**FIRST MODIFICATION TO AGREEMENT FOR TEMPORARY PRIVATE CROSSINGS,
HAUL ROAD, TWO SPUR ROADS, AND CROSSING APPROACHES**

From: Kuhl, Brooke
To: [Hausrath, Katherine](#)
Cc: [Ford, Jim](#); [Harris, Harley](#); [Capdeville, Mary](#)
Subject: RE: Parrot bid package, minor modifications to the BNSF drawings
Date: Wednesday, April 25, 2018 1:54:09 PM

Re: **Construction Drawing vs. Access Agreement Drawing Comparison**

HAUL ROAD SHEET
INDEX PLAN

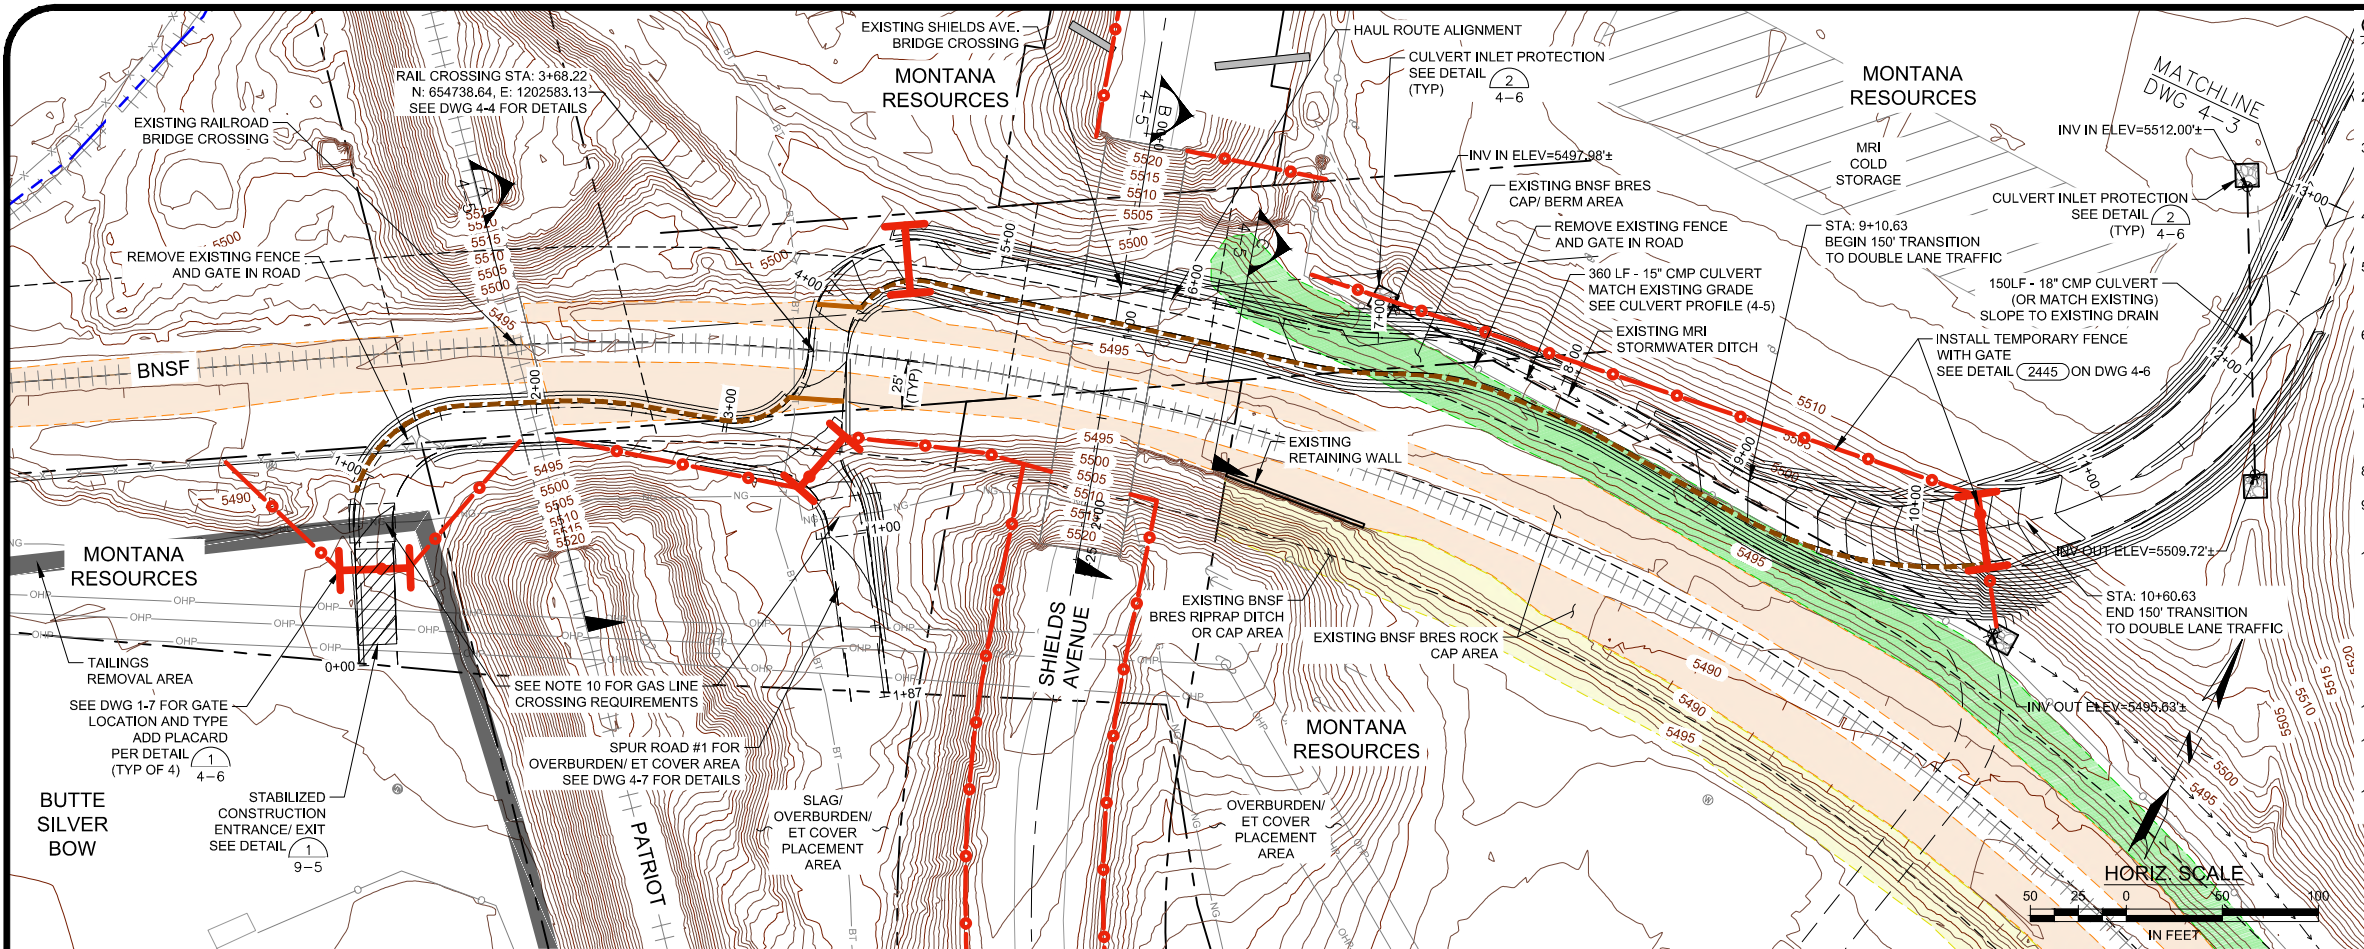
Sheet 4-1 – Haul Road Sheet Index Plan (Dated 12/5/2017)

- Sheet 4-1 in the Agreement is consistent with Sheet 4-1 of the Bid #1 Construction Drawings. There some minor changes to this sheet:
 - o Stationing labels were removed from the Northwestern Energy power line.
 - o Duplicative stationing labels were removed from haul road.
 - o Labeling was cleaned up to better reflect site conditions.
 - o No substantive changes were made to the the BNSF Premises, including the area depicted as "Existing BNSF Riprap Ditch or Cap Area."

HAUL ROAD PLAN AND PROFILE

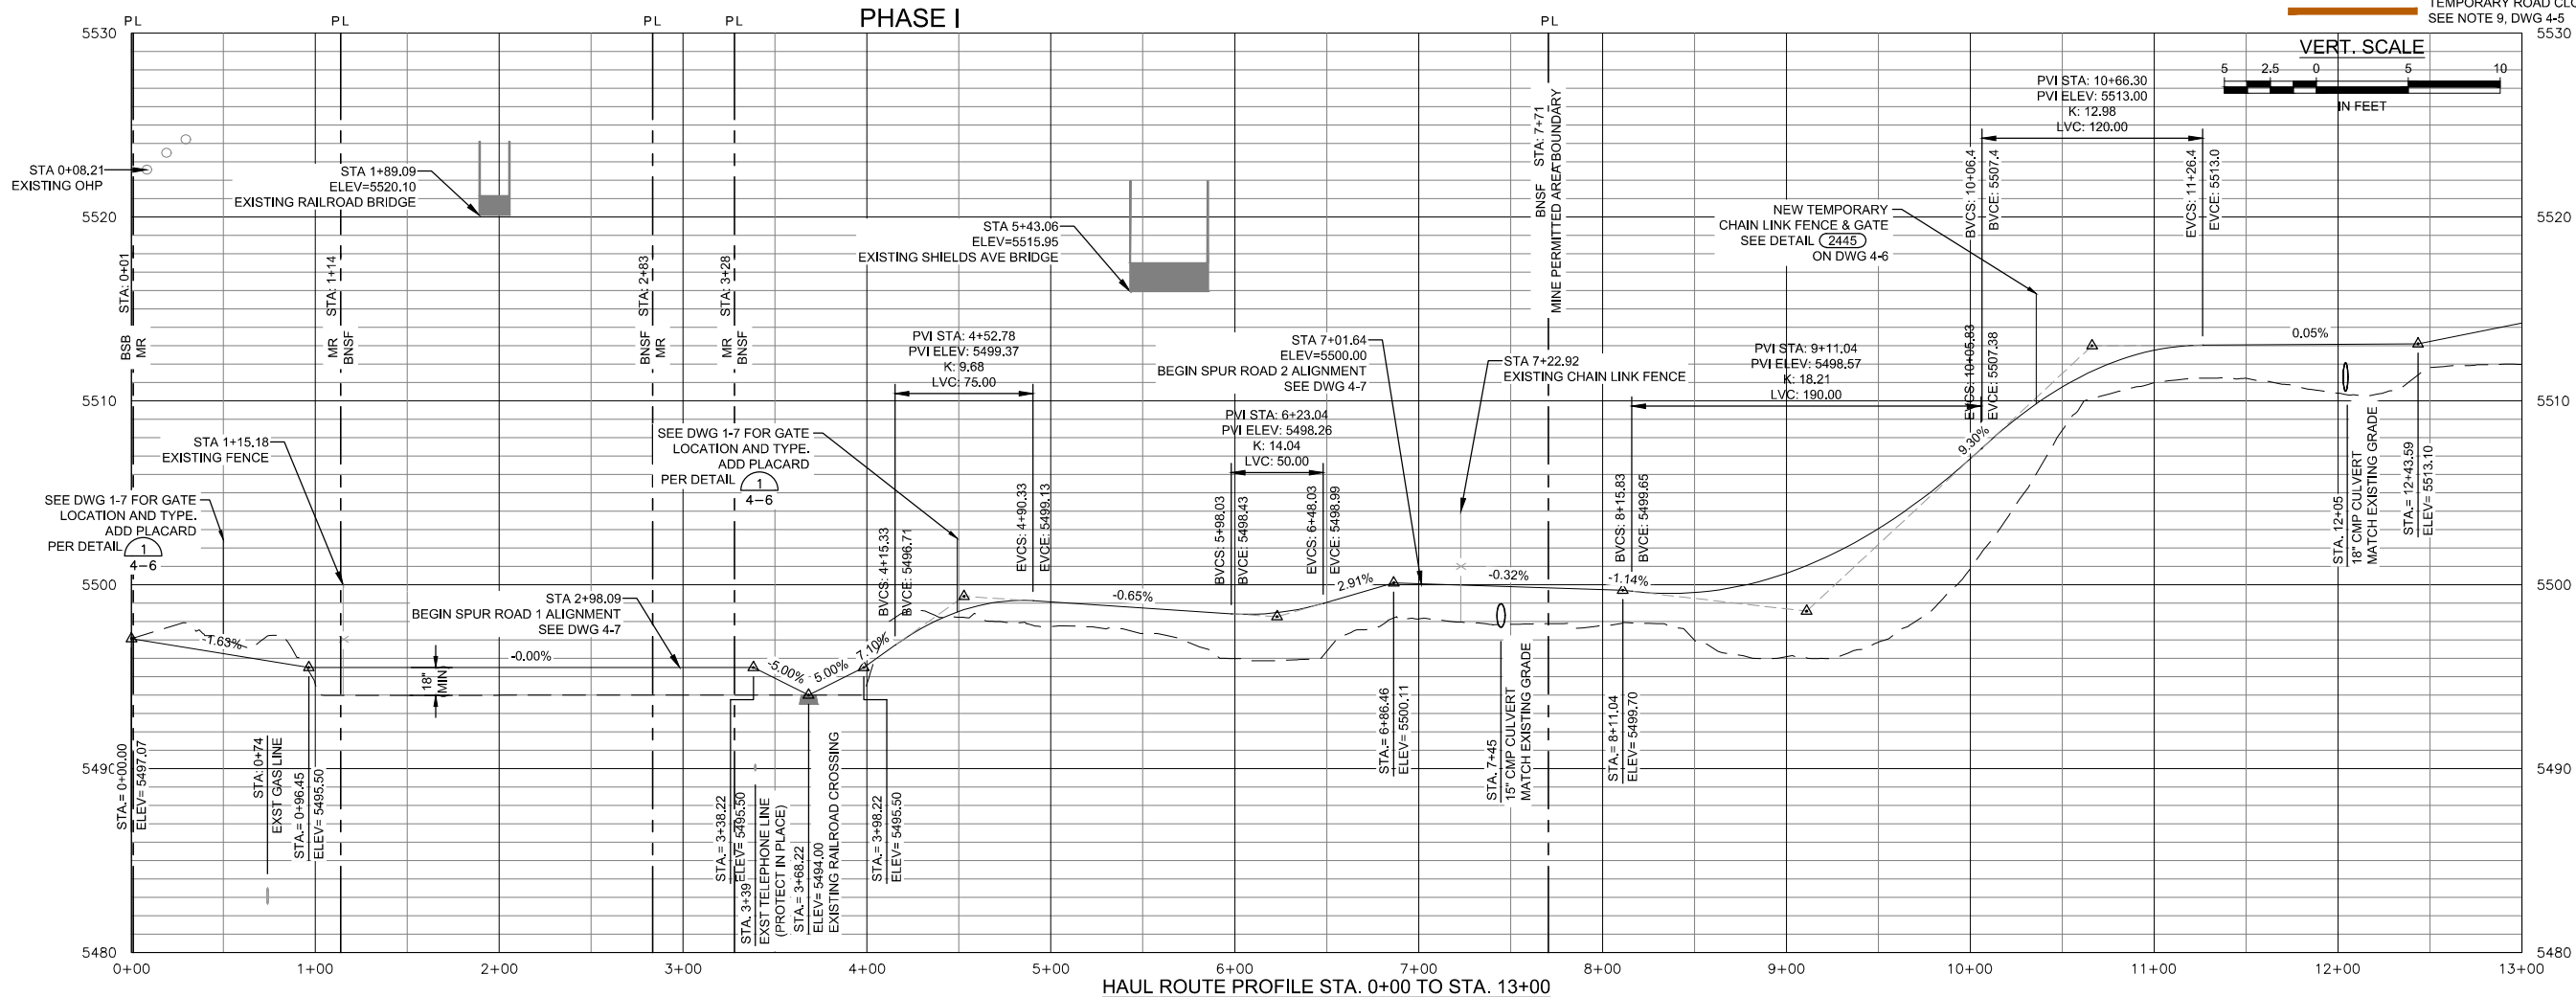
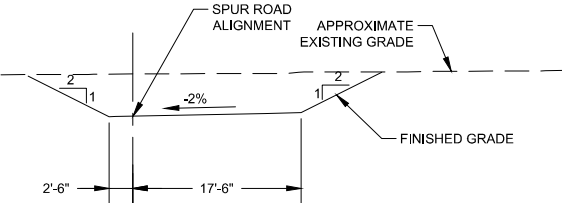
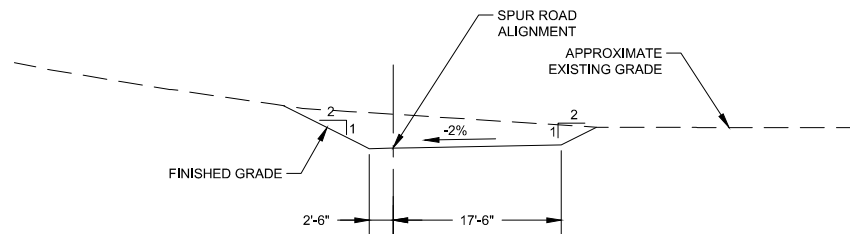
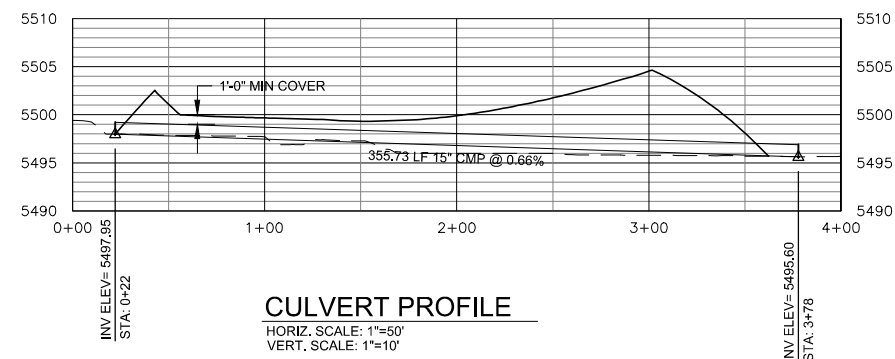
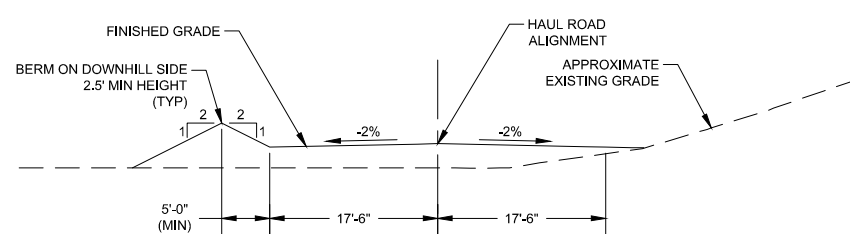
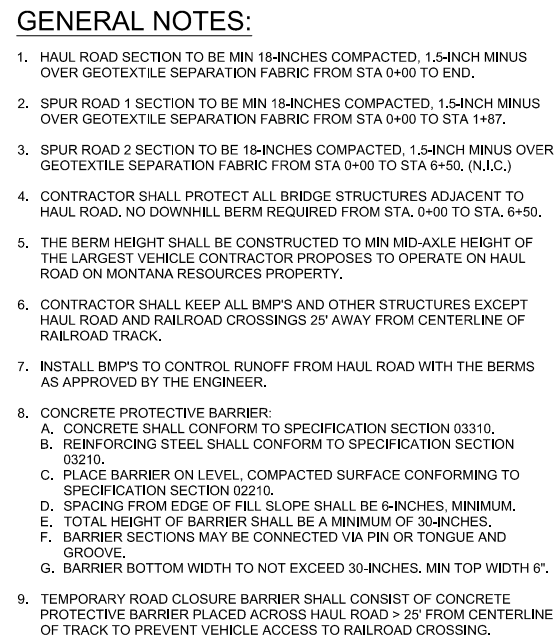
Sheet 4-2 – Haul Road Plan and Profile STA 0+00 to STA 13+00 (Dated 12/5/2017)

- Sheet 4-2 in the Agreement is consistent with Sheet 4-2 of the Bid #1 Construction Drawings. There are some minor changes to this sheet:
 - o Stationing labels were removed from the Northwestern Energy power line.
 - o Duplicative stationing labels were removed from haul road.
 - o Labeling was cleaned up to better reflect site conditions.
 - o Construction notes 11, 12, and 13 were added to provide clarification on the Contractor's responsibilities.
 - o No substantive changes were made to the the BNSF Premises, including the area depicted as "Existing BNSF Riprap Ditch or Cap Area."

[illegible]HAUL ROAD SPUR
PLAN AND PROFILE

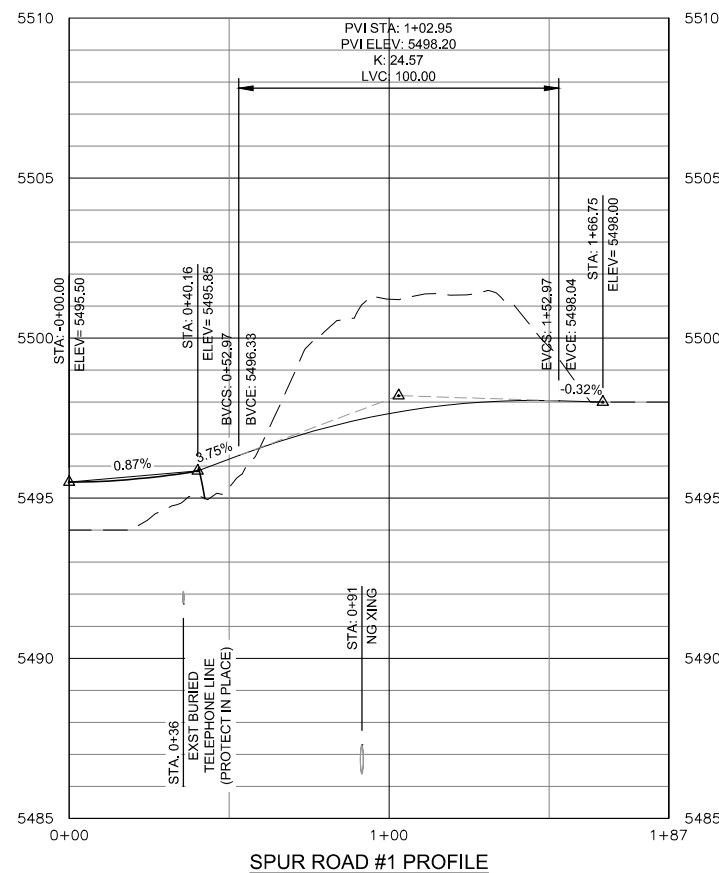
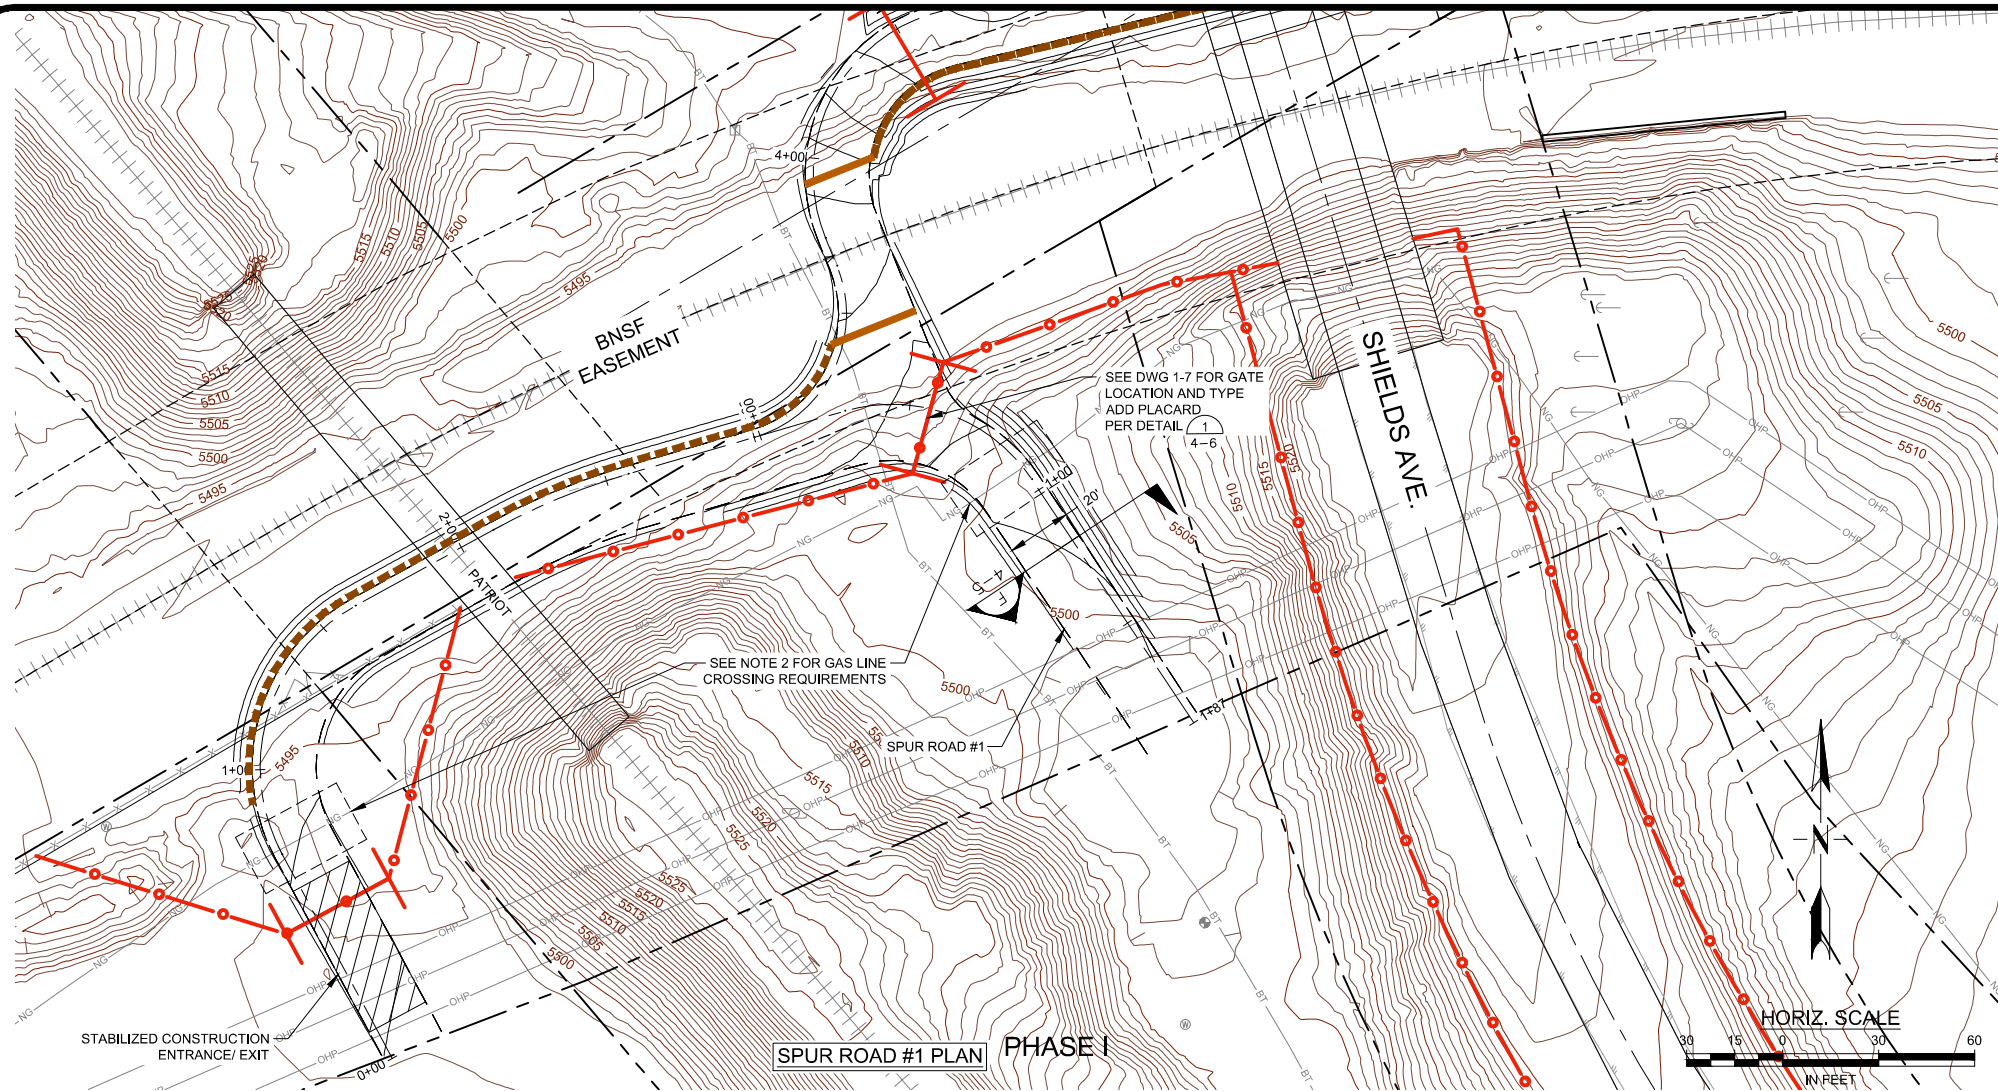
Sheet 4-7 – Haul Road Spur Plan and Profile (Dated 10/11/2017)

- Sheet 4-7 in the Agreement is consistent with Sheet 4-7 of the Bid #1 Construction Drawings. There are some slight changes to labeling, but no changes to line work or design features.
